ORIGINATION FORM

Proposed Revisions to a Standard Plans Index (Please provide all information — Incomplete forms will be returned)

Index Number: 102-604

Index Title: Two-Lane, Two-Way, Work in intersection

ADDED DETAILS FROM
102-605 AS NEW SHEET 1

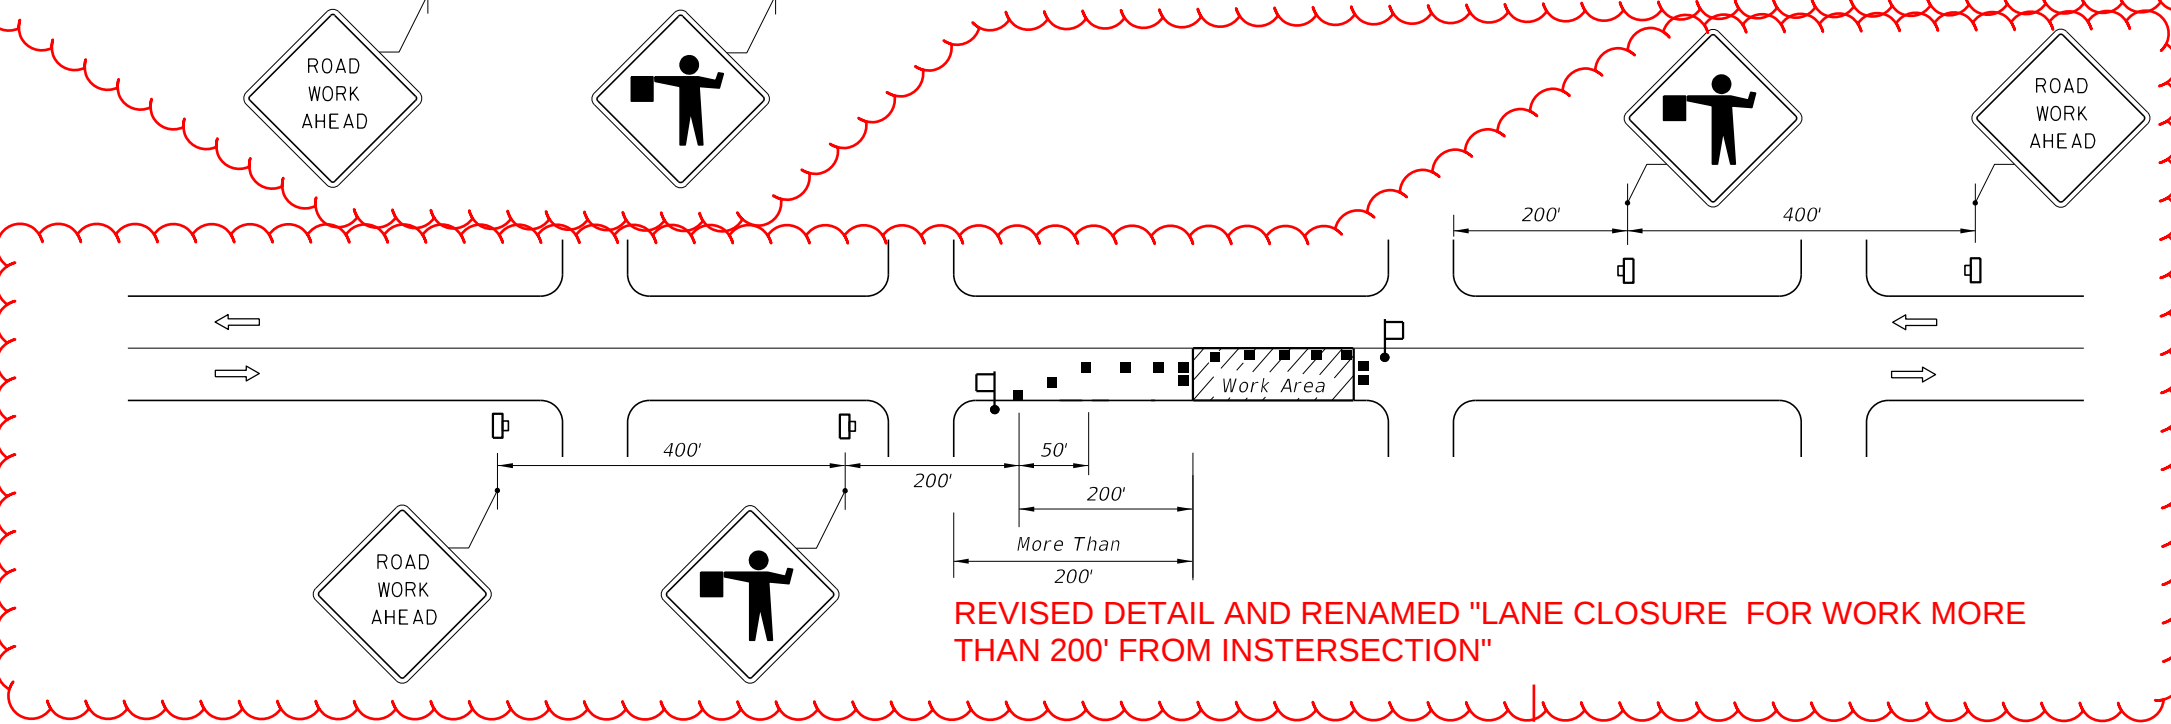
REVISED DETAIL AND RENAMED "LANE CLOSURE FOR WORK LESS THAN 200' FROM INTERSECTION"

REVISED DETAIL AND RENAMED "LANE CLOSURE FOR WORK MORE THAN 200' FROM INTERSECTION"

TWO-LANE, TWO-WAY ROADWAY, INTERSECTION WORK

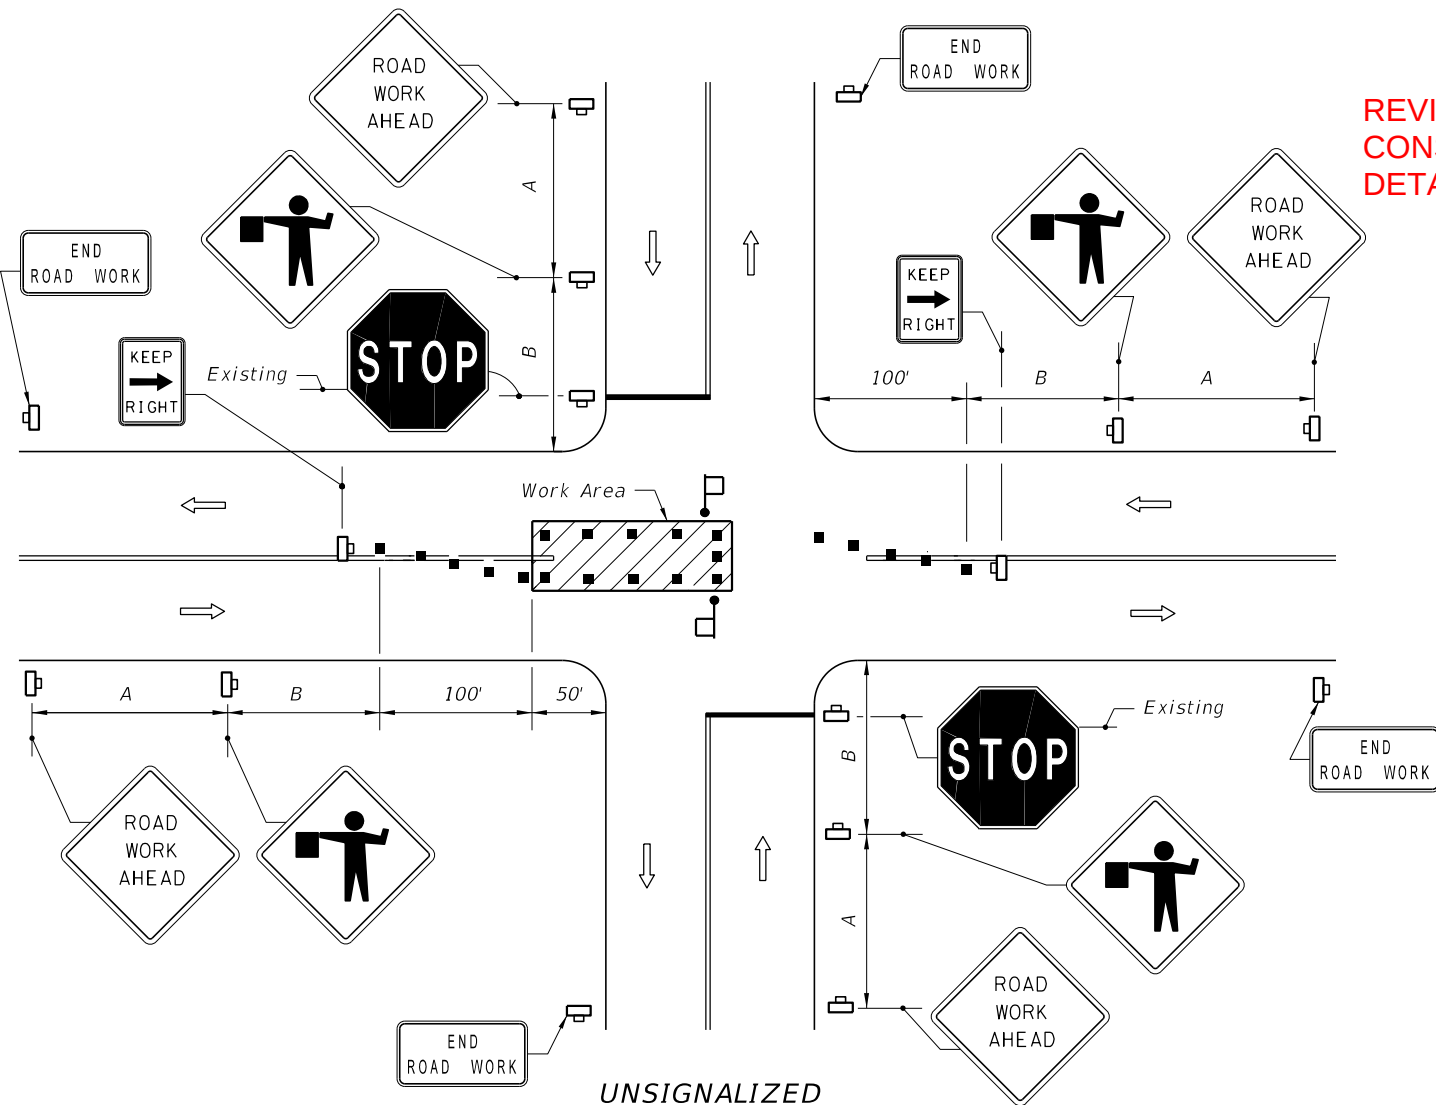
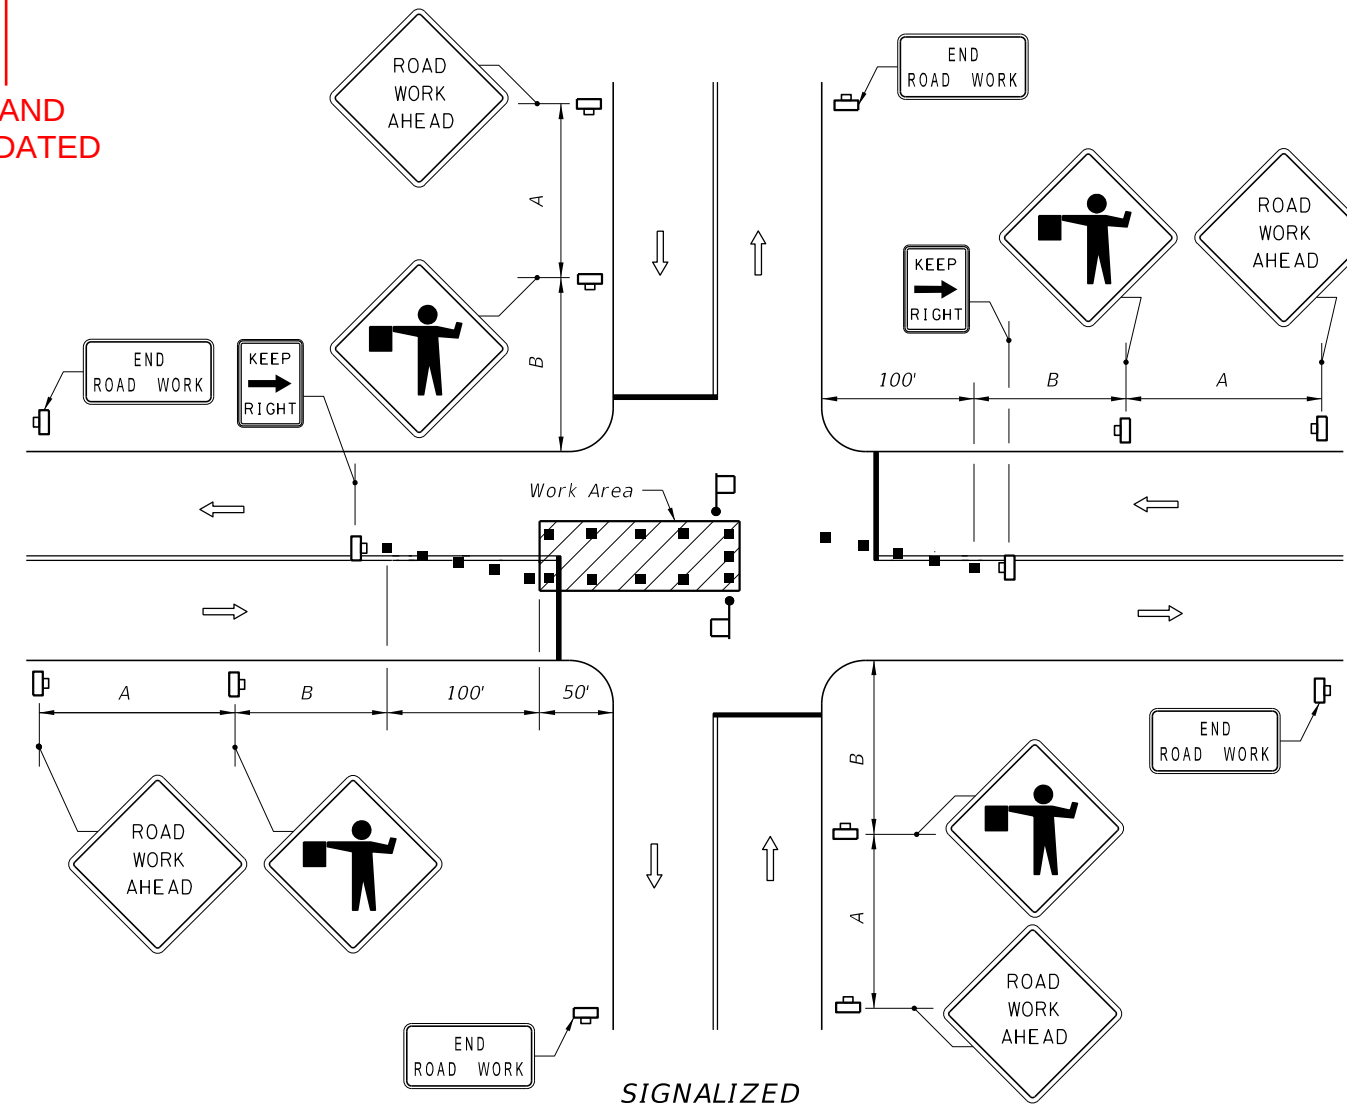
REVISED AND
CONSOLIDATED
DETAILS

DELETED - MOVED TO 102-600

REVISED AND
CONSOLIDATED
NOTES, MOVED TO
SHEET 1

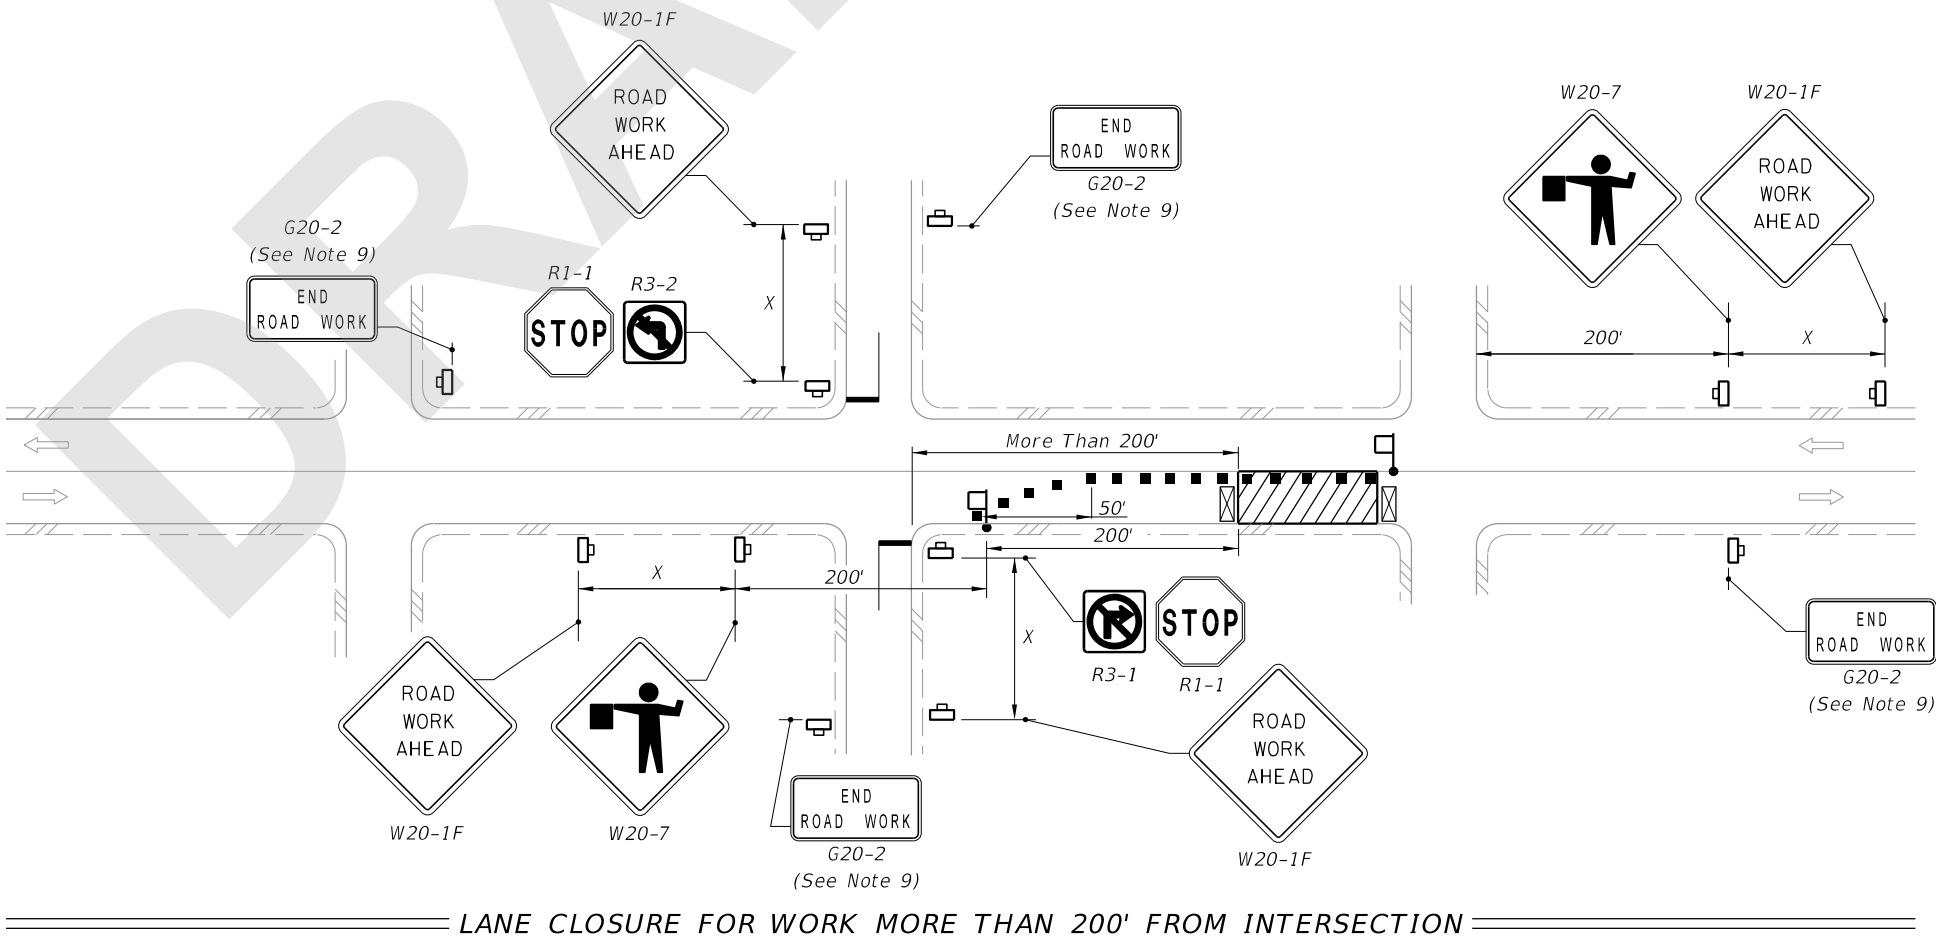
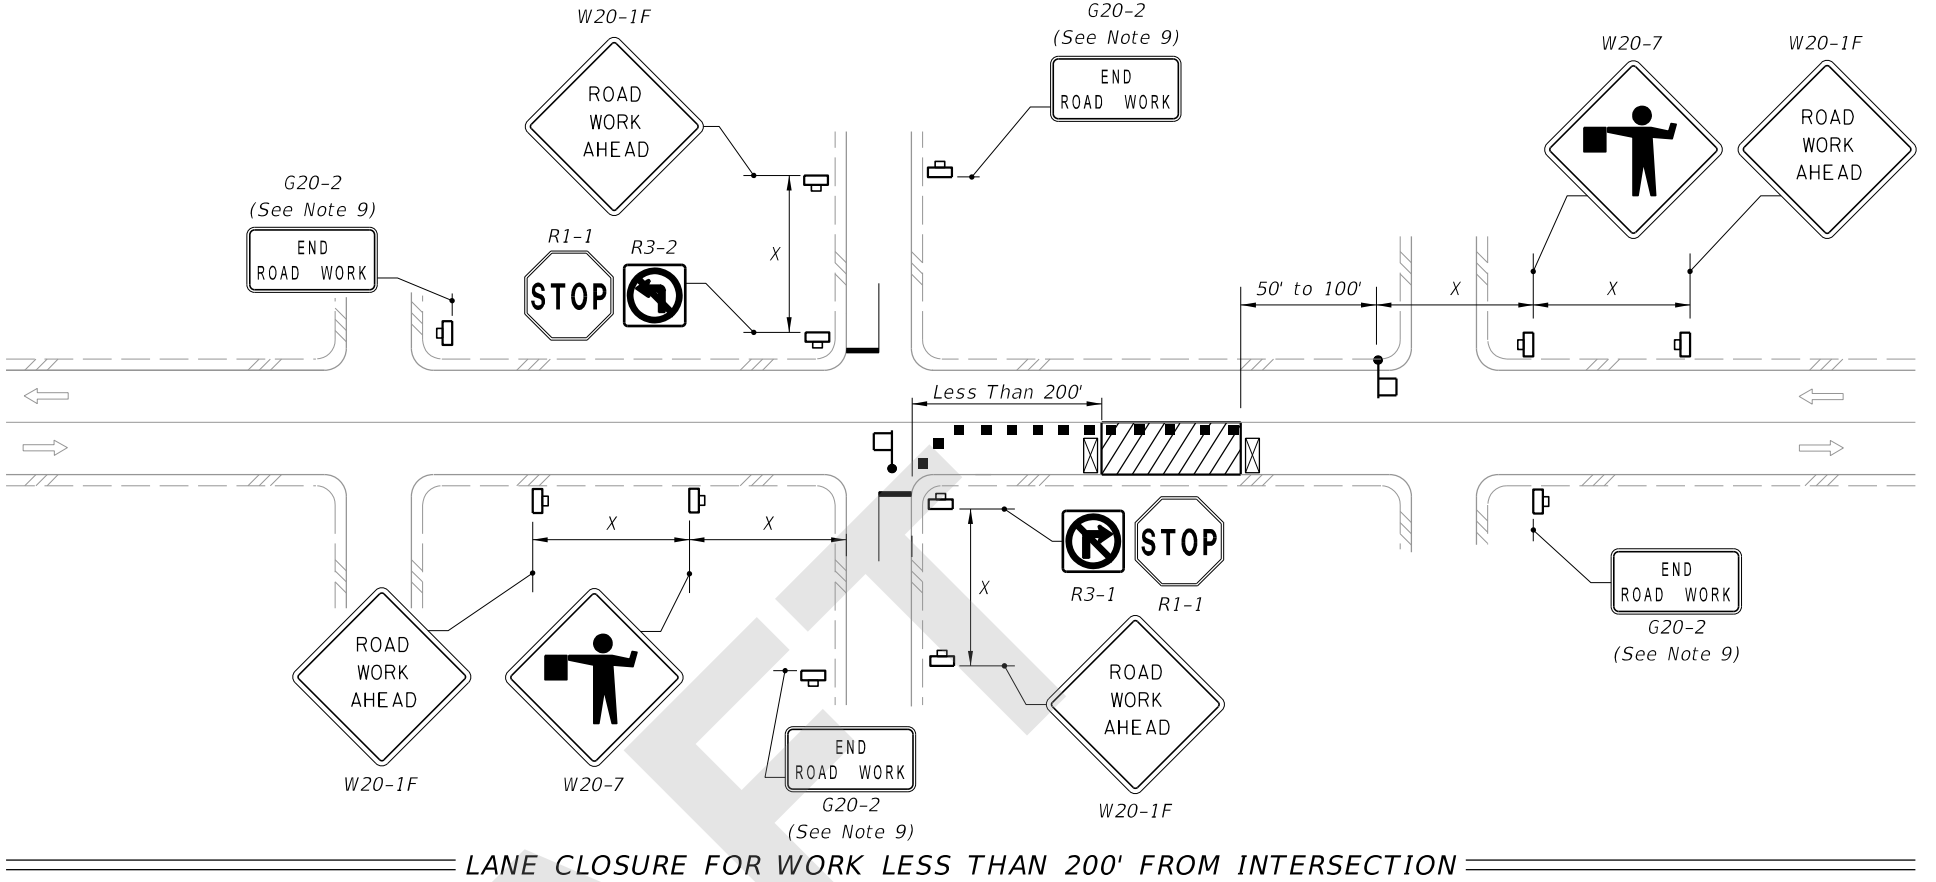
Sheet 1: Added Details from 102-605 as New Sheet 1; Revised Details and General Notes; Deleted Duration Notes and Conditions; Renamed Index; Moved Original Sheet 1 Details to Sheet 2.

WORK IN INTERSECTION OF TWO-LANE ROADWAY

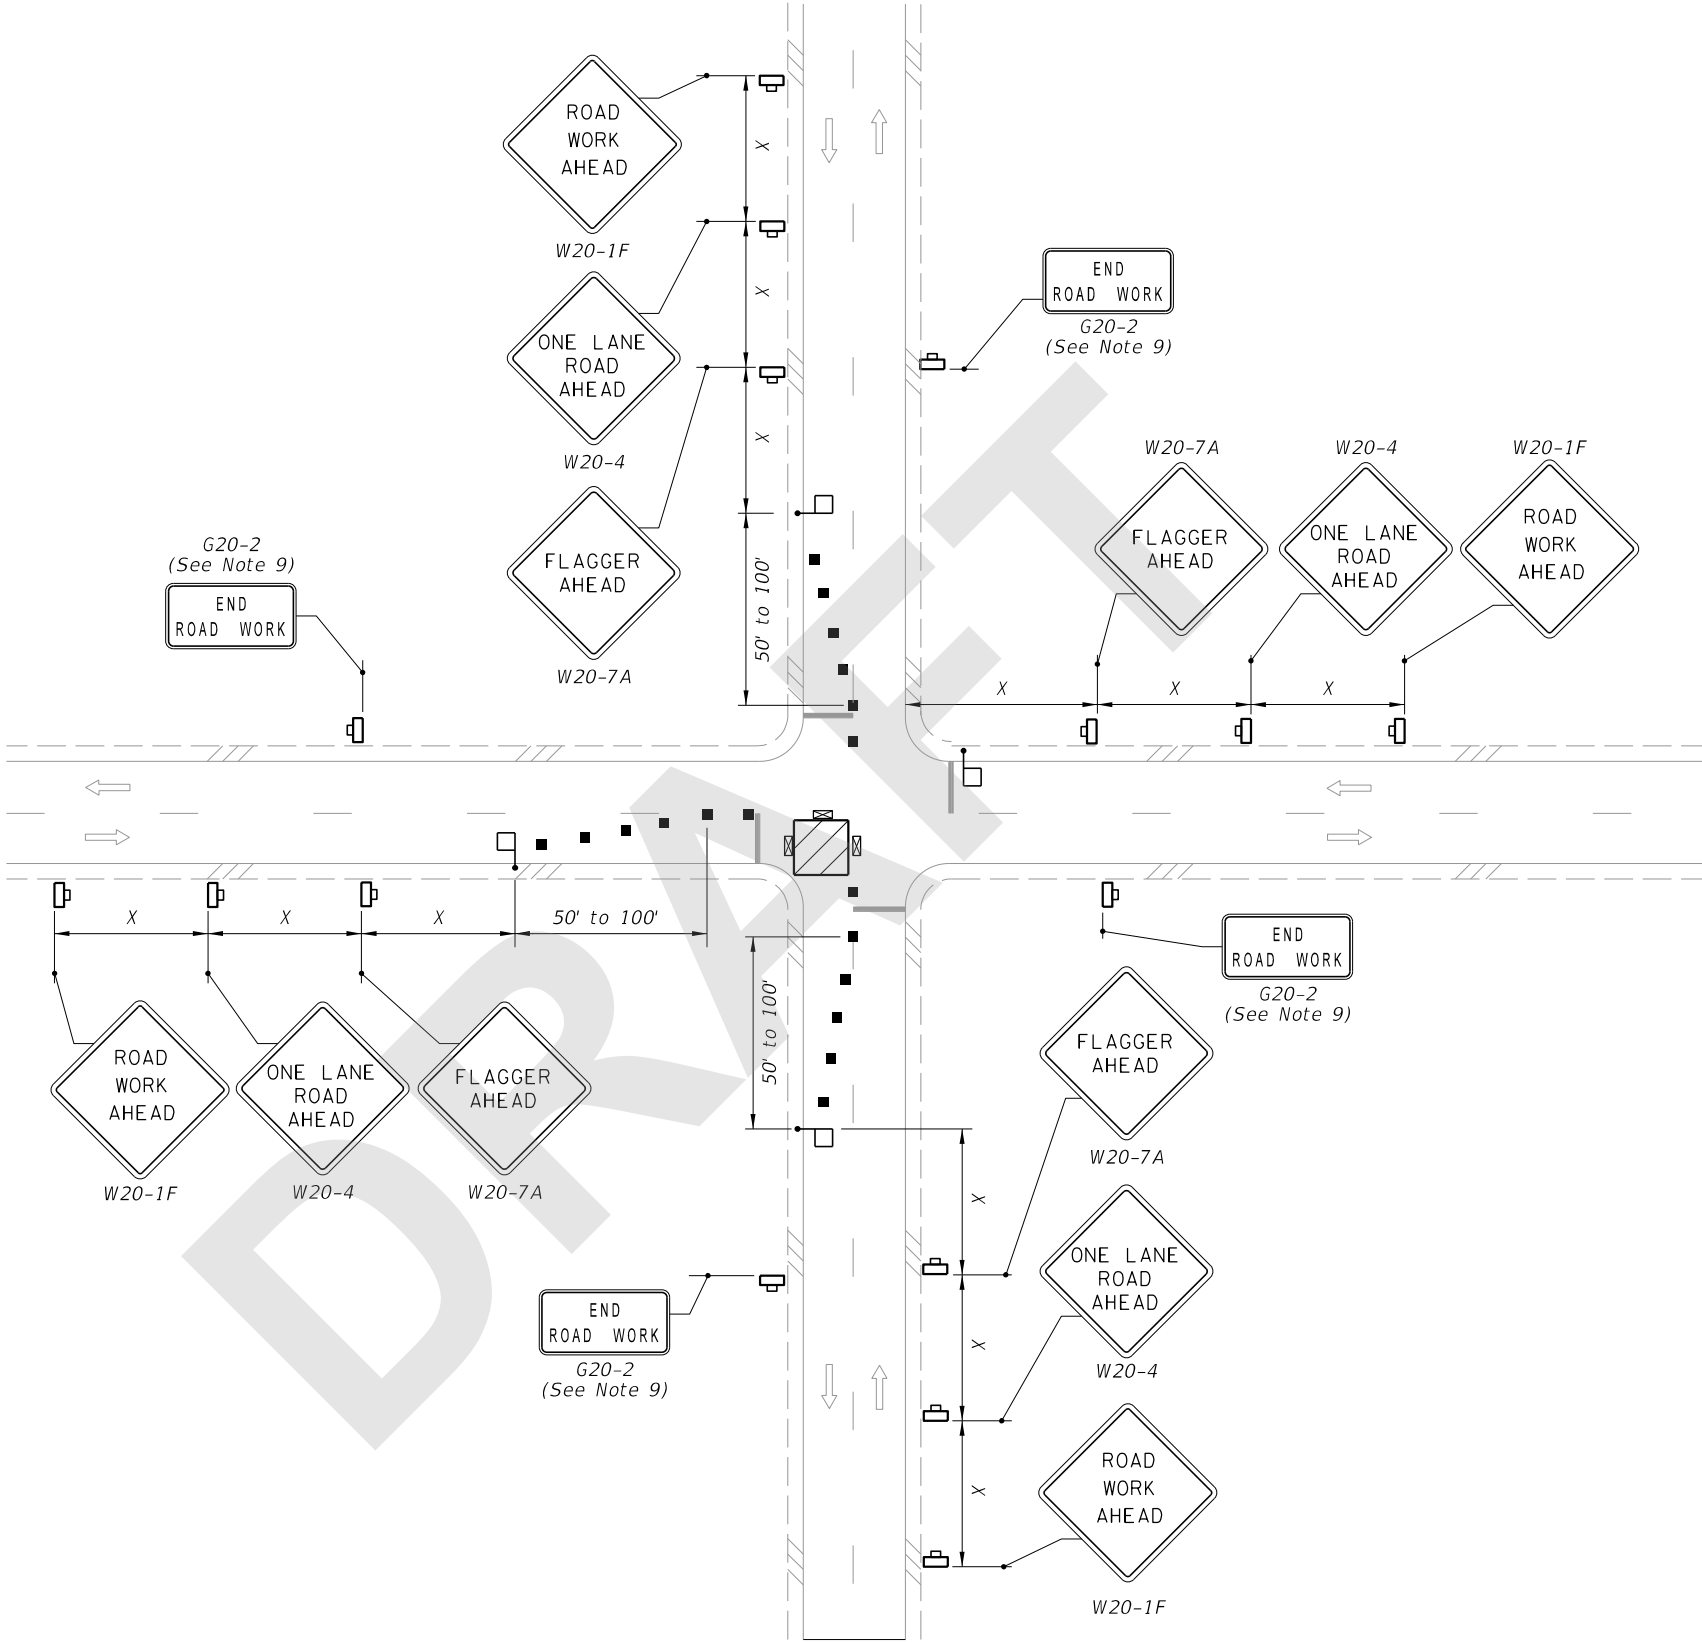
Sheet 2: Revised and Consolidated Details; Revised Notes; Deleted Duration Notes and Conditions; Deleted 'Distance Between Signs' Table (Moved to 102-600).
